# Access Compliance Report

## Public Rights-of-Way

Intersection ID: 54415	Main Street: GLANMIRE_DR	Cross Street: ARDREY_KELL_RD	Location: SW
ADA ID: 51FF4D3A4DC1	Ramp Type: Directional1	Initial Pass/Fail: Fail	Overall Compliance: No
		Severity Score: 12.5

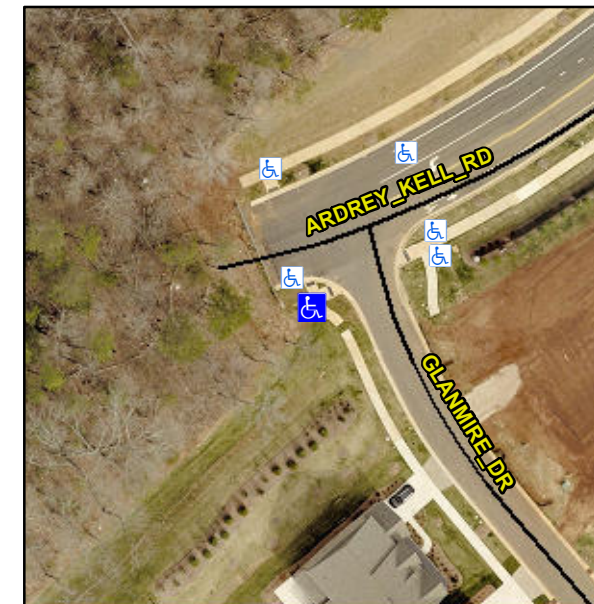
**R304.2.2**

Compliance	Description	Data	Compliance	Description	Data
N/A	Ramp Length (in)	79.0	N/A	Grade Break?	N/A
Yes	Ramp Width (in)	68.0	N/A	Grade Break Slope (%)	0.0
No	Ramp Slope (%)	11.4	N/A	Grade Break XSlope (%)	0.0
Yes	Ramp XSlope (%)	0.5			
N/A	Flare Type LT	N/A	N/A	Flare Type RT	N/A
N/A	Flare Slope LT (%)	N/A	N/A	Flare Slope RT (%)	0.0
N/A	Flare Traversable LT?	N/A	N/A	Flare Traversable RT?	N/A
N/A	Landing Length (in)	0.0	N/A	DWS Provided?	N/A
N/A	Landing Width (in)	0.0	N/A	DWS Contrast?	N/A
N/A	Landing Slope (%)	0.0	N/A	DWS Length (in)	N/A
N/A	Landing X Slope (%)	0.0	N/A	DWS Full Width?	N/A
N/A	Landing Curb? (Y/N)	N/A	N/A	DWS Offset LT (in)	N/A
N/A	Shared Landing?	N/A	N/A	DWS Offset RT (in)	N/A
N/A	Gutter Ponding?	0.0	N/A	Gutter Slope (%)	N/A
N/A	Gutter Lip Ht (in)	0.0	N/A	Gutter X Slope (%)	N/A
N/A	Painted X Walk1?	No		Road Slope (%)	1.8
	X Walk 1 Direction	To E		Road X Slope (%)	2.0
	X Walk 1 Width (in)	N/A		Clear Space?	N/A

**Remove & Replace Entire Ramp.**
